Comments on Puget Sound Energy's 2017 Integrated Resource Plan

Washington Utilities and Transportation
Commission Docket Nos. UE-160918 & UE-
160919

Prepared for Sierra Club

January 19, 2018

Figure 1. Wind Capital Costs, Lazard Historical and PSE IRP Forecasts

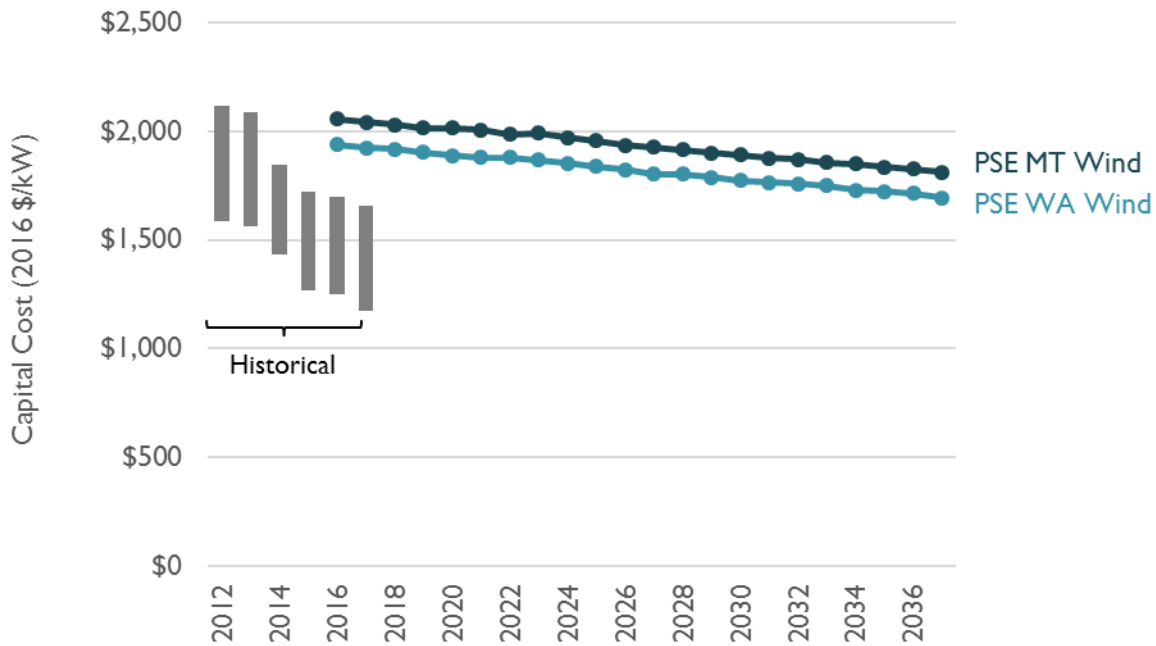
Figure 1 depicts PSE's forecasted capital costs for Washington and Montana wind in comparison to historical Lazard capital cost estimates. This shows that Lazard's estimates of 2017 wind capital costs are 15 percent lower than PSE's Washington wind assumptions and 23 percent lower than PSE's assumptions for Montana wind. Under PSE's projected trajectory, wind capital costs remain above currently achievable levels through 2037.

Figure 2. Solar Capital Costs, Lazard Historical and PSE IRP Forecasts

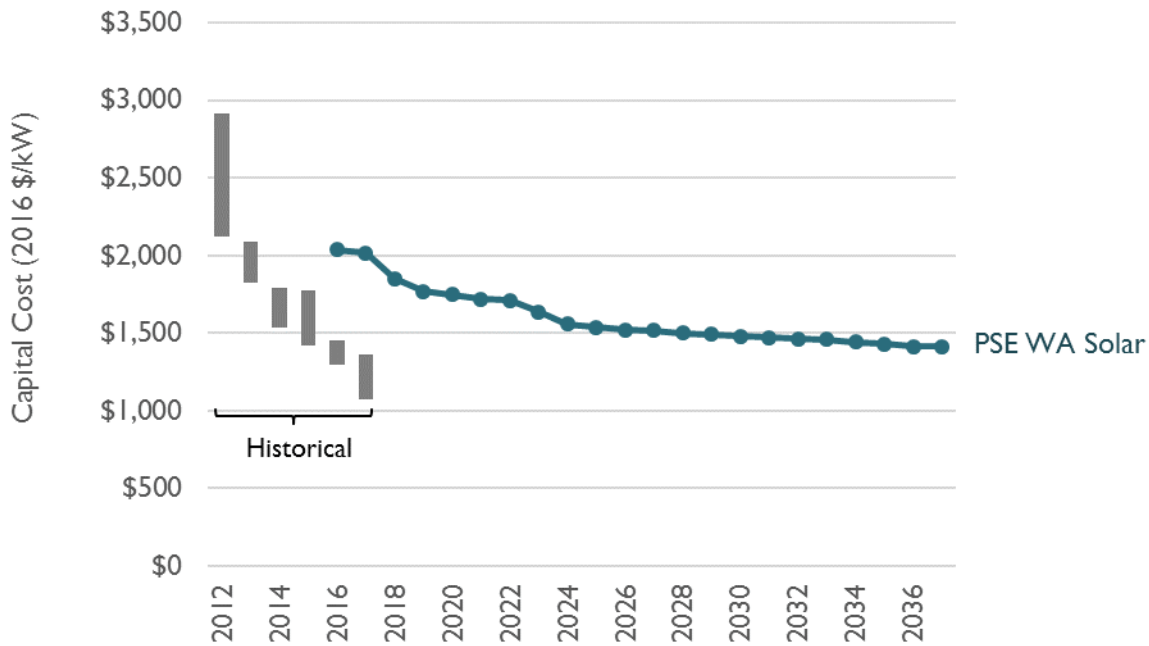
PSE’s solar cost assumptions appear to be even more overstated than its wind costs in the near term. Figure 2 shows that PSE’s cost estimates are about 50 percent too high for 2017. Although PSE forecasts future declines in solar costs, its projection still remains higher than Lazard’s estimate of current costs. Moreover, even PSE’s “lower” solar cost sensitivity assumes capital costs of \$1,755 per kilowatt (kW), about 30 percent higher than current capital costs per Lazard.²¹
